FED. ROAD DIST. NO.	STATE	FED. AID PROJ. NO.	FISCAL YEAR	SHEET NO.	TOTAL SHEETS
HAWAII	HAW.	BR-083-1(42)	2009	C.O.20	121

ROADWAY PLAN AND PROFILE

KAMEHAMEHA HIGHWAY - REPLACEMENT OF SOUTH PUNALUU STREAM BRIDGE
Federal Aid Project No. BR-083-1(42)

SHEET No. C24 OF 40 SHEETS

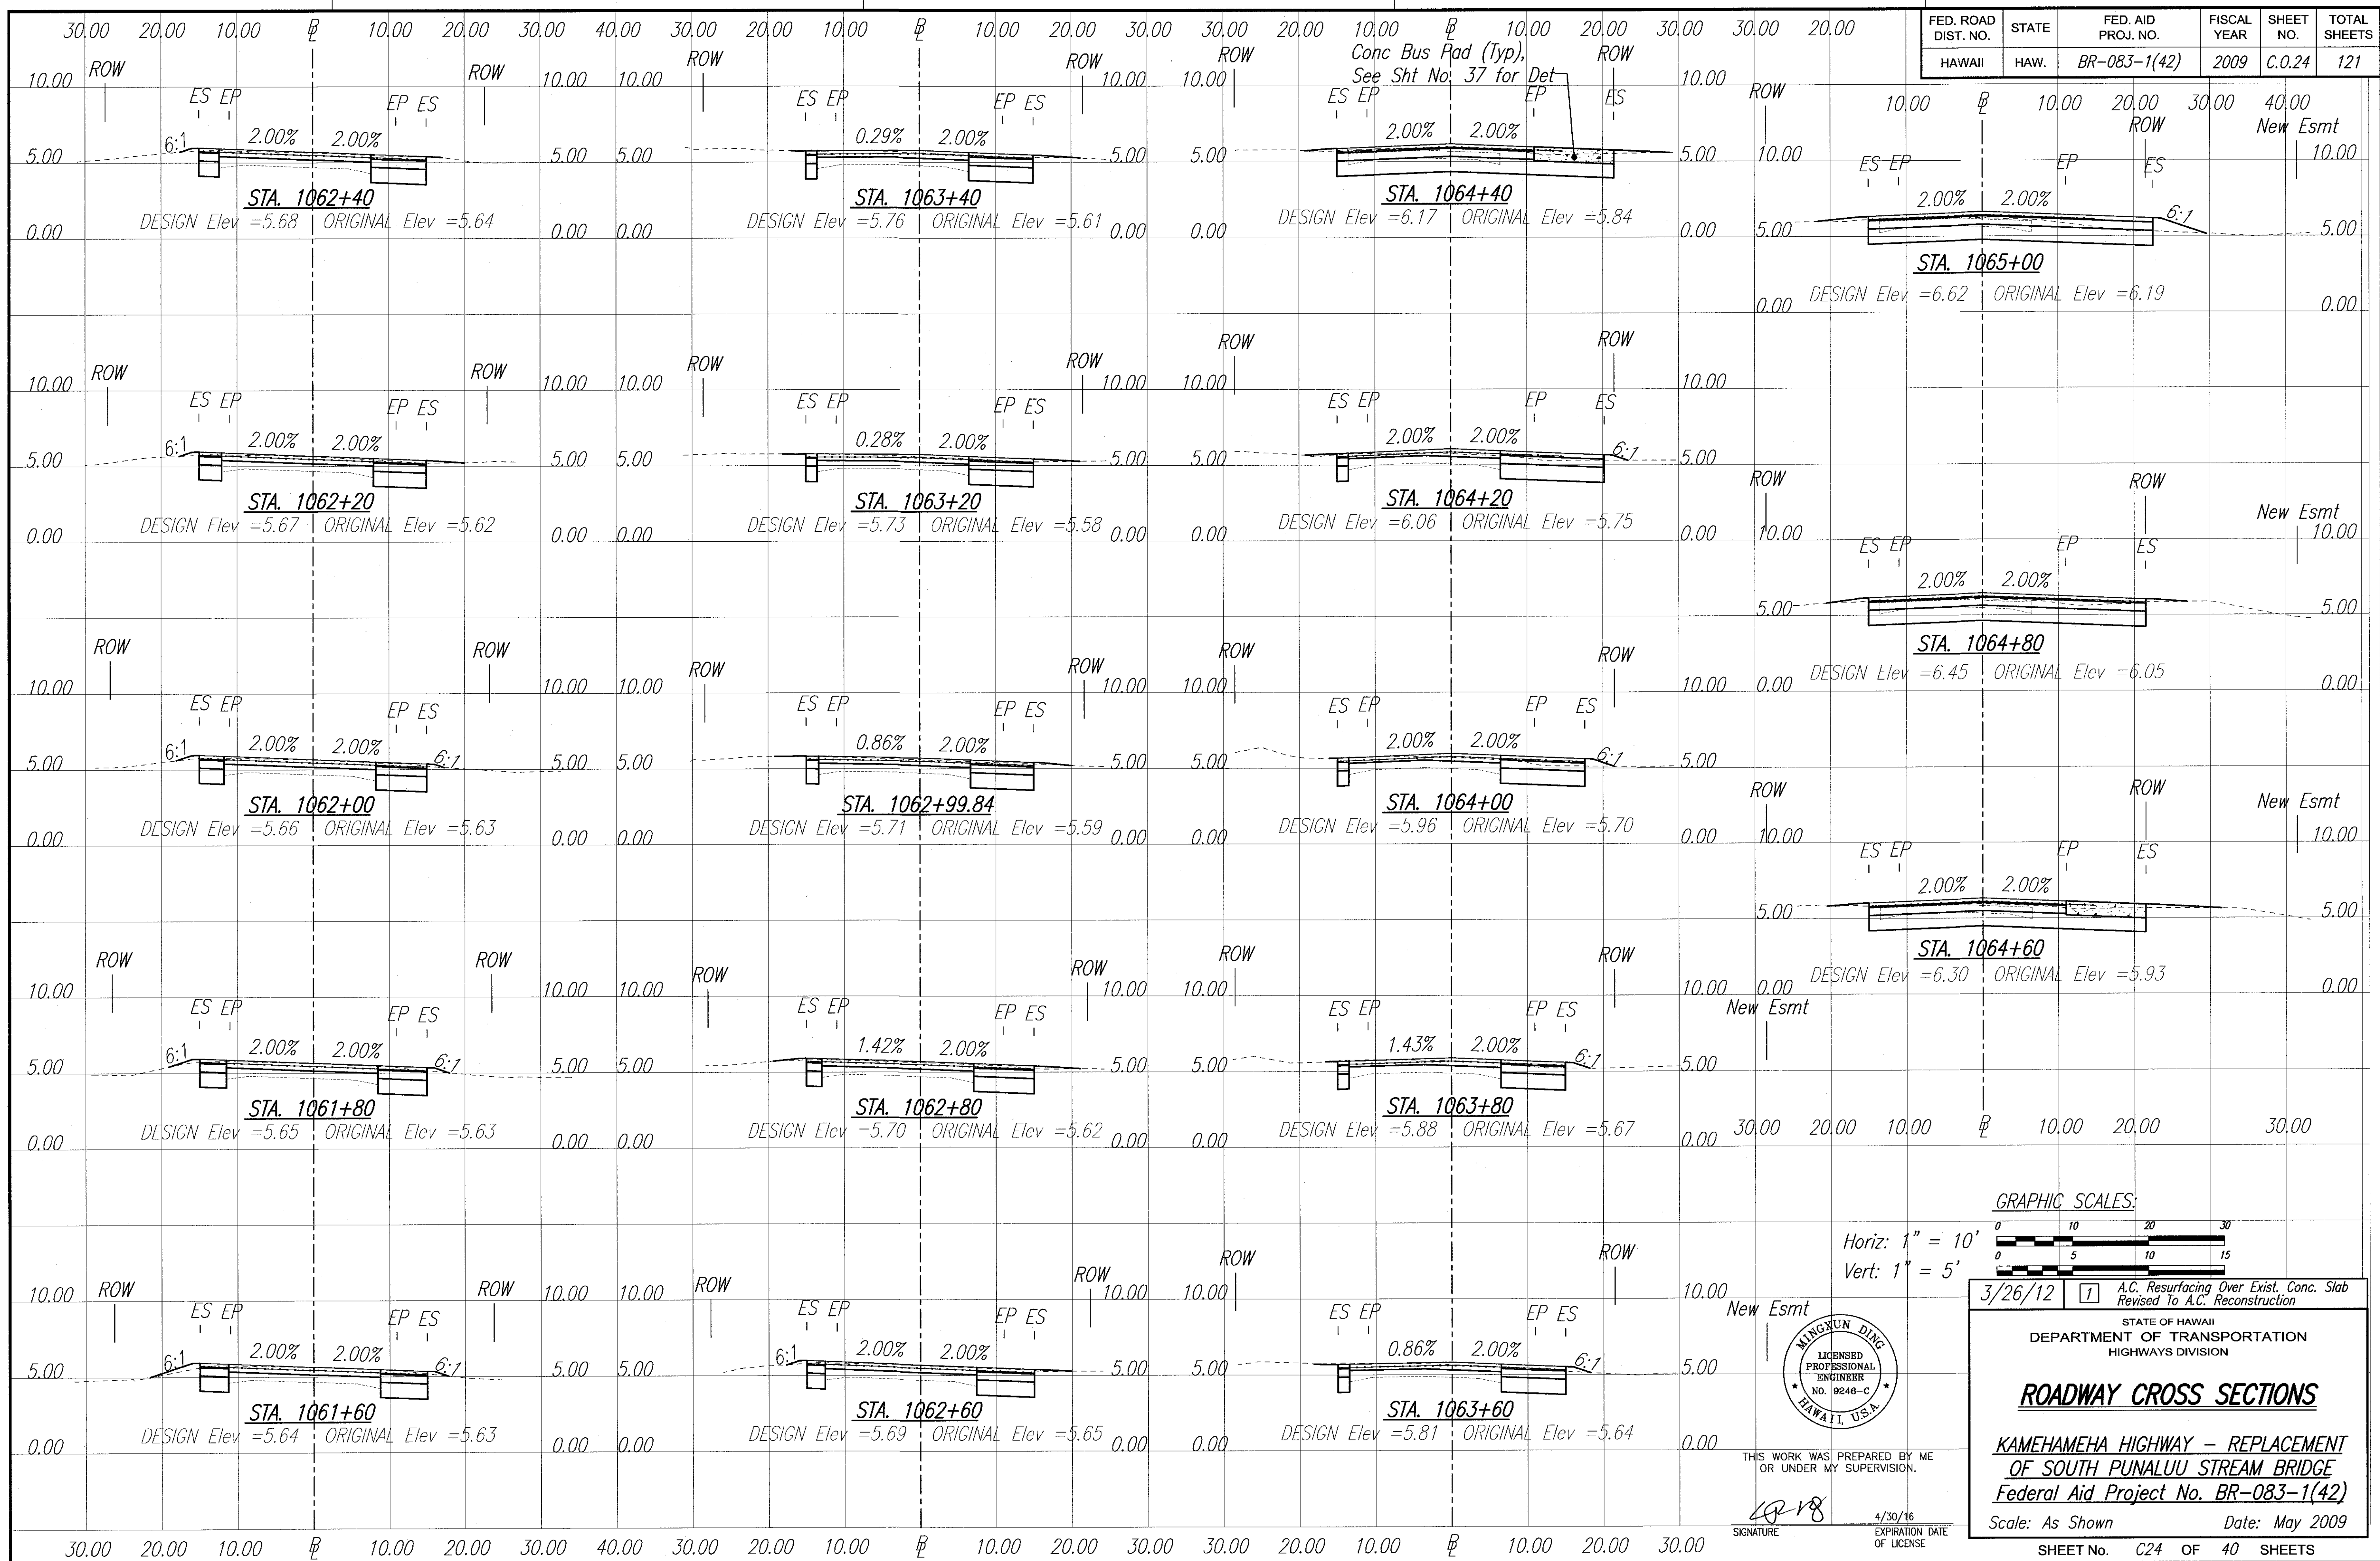
3/26/12 1 A.C. Resurfacing Over Exist. Conc. Slab
 Revised To A.C. Reconstruction

SHEET No. C26 OF 40 SHEETS

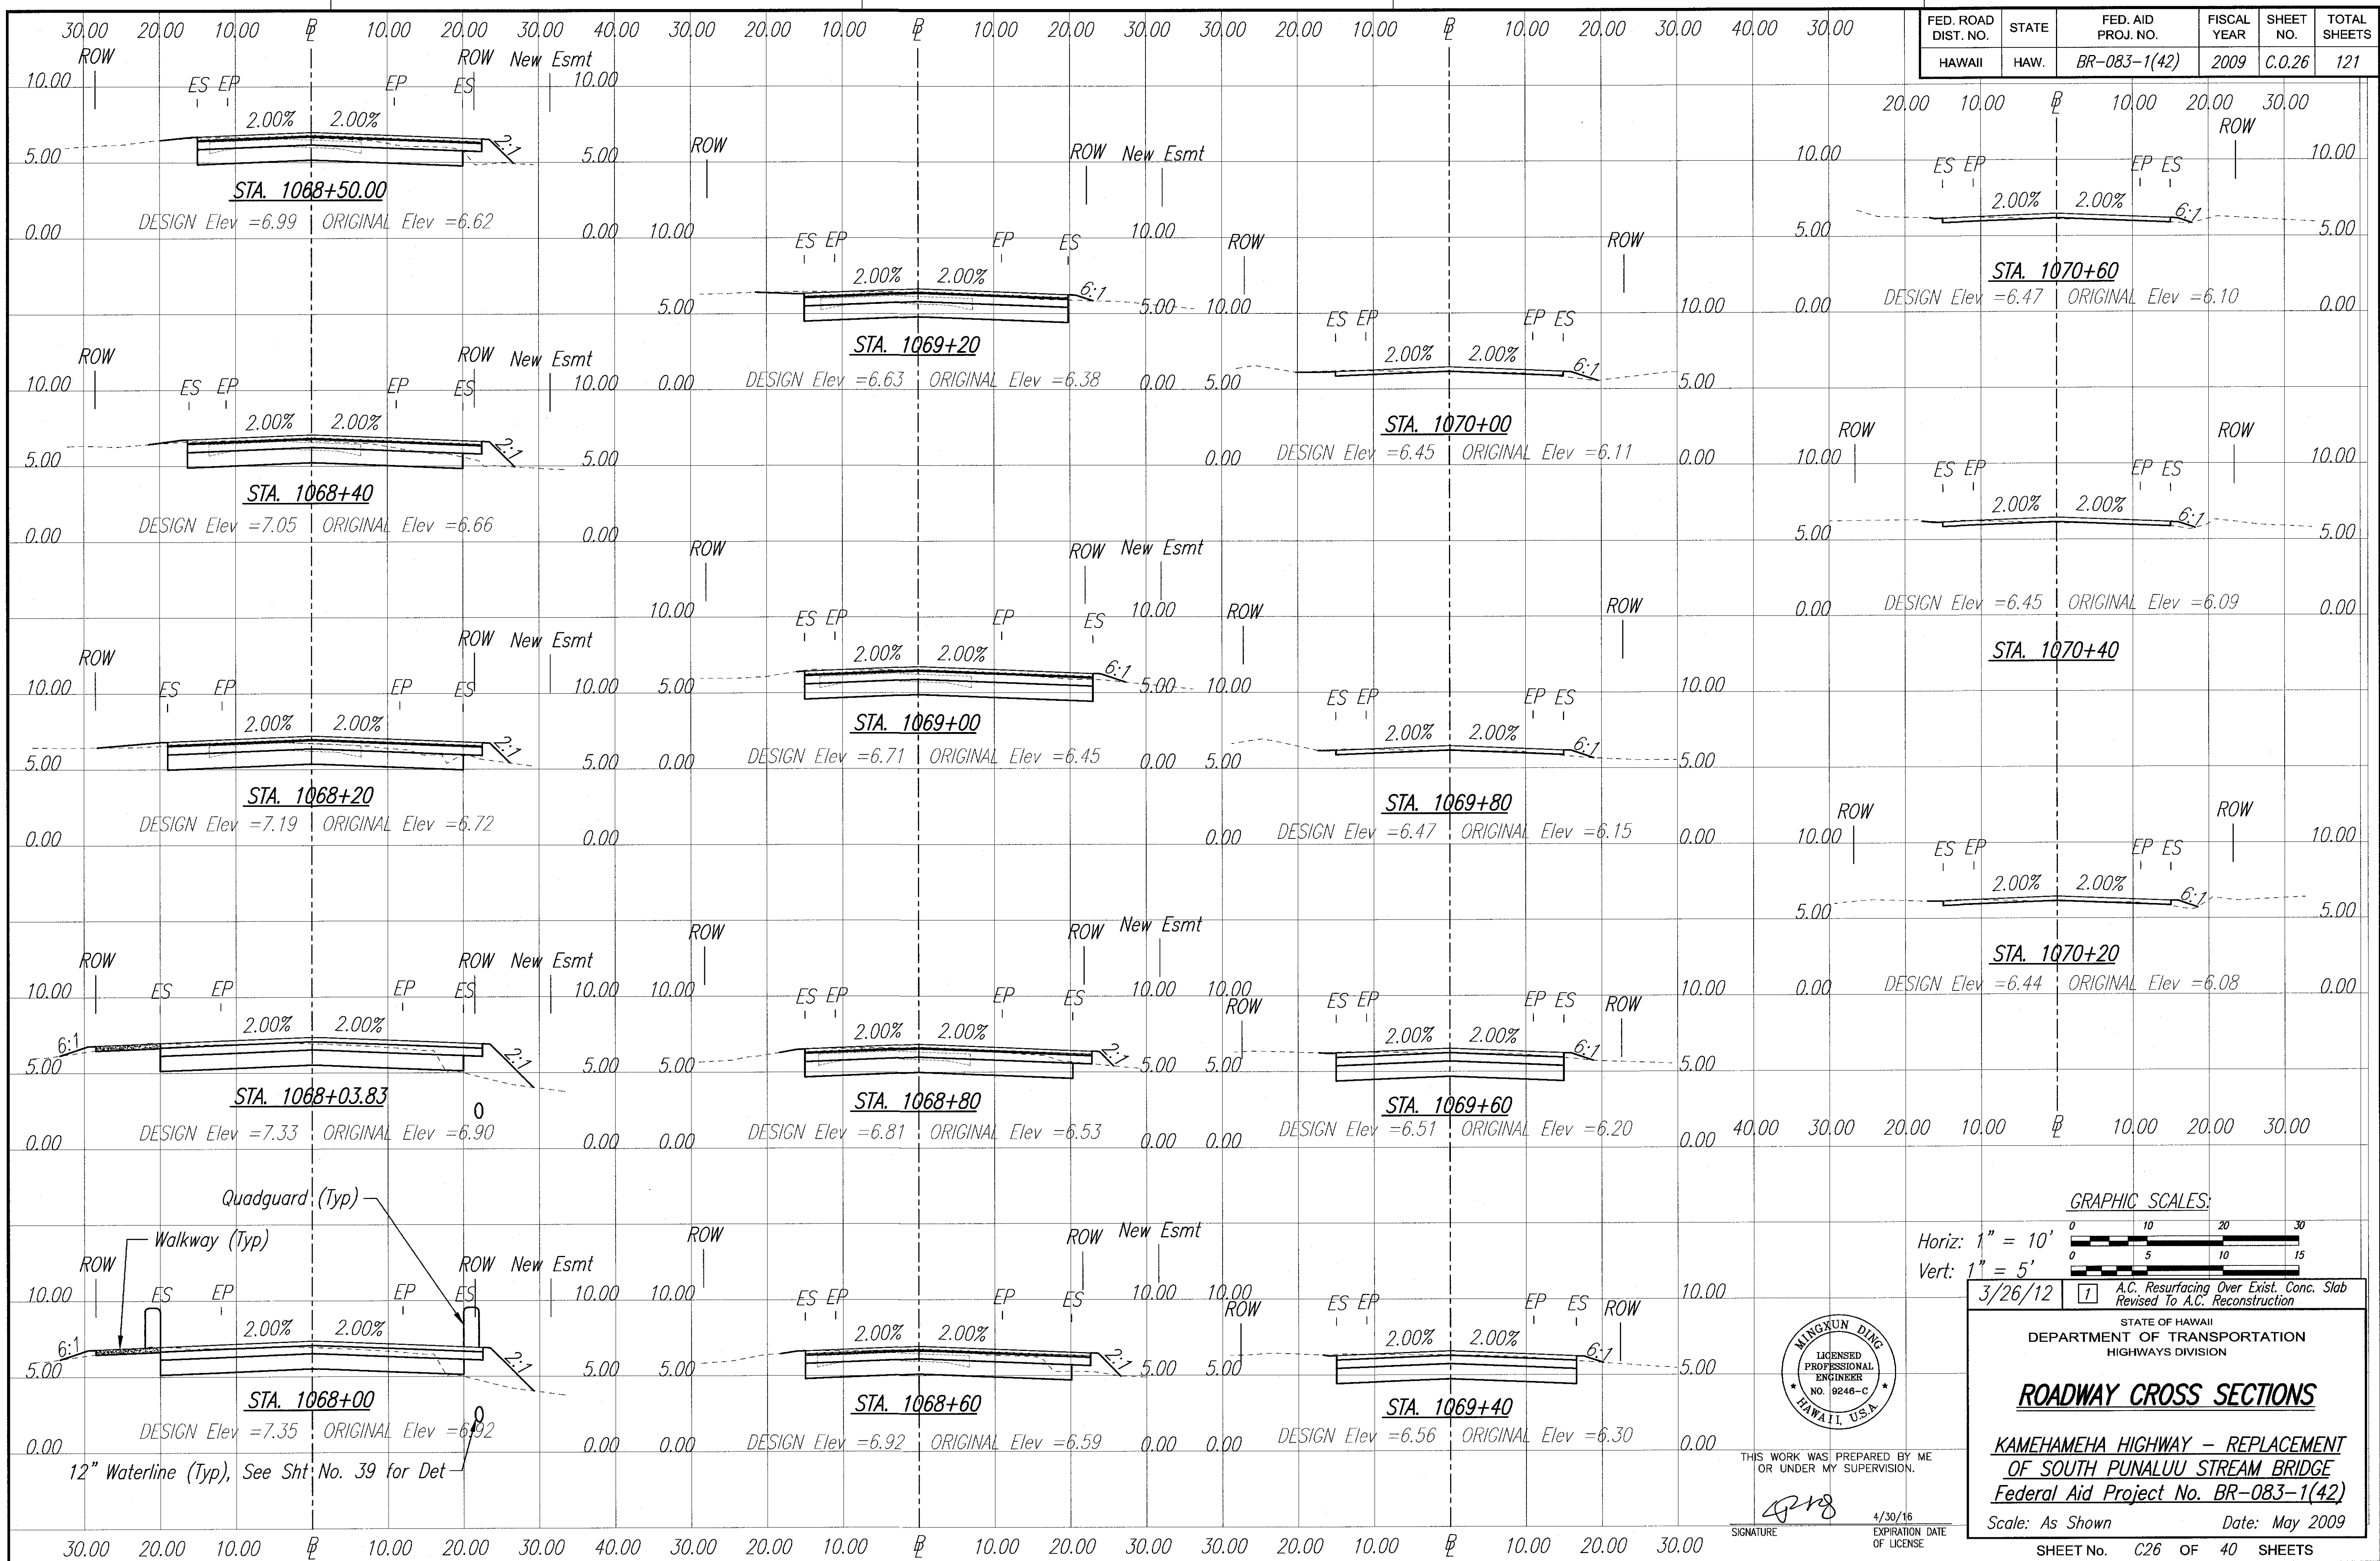
3/26/12
 1 A.C. Resurfacing Over Exist. Conc. Slab
 Revised To A.C. Reconstruction
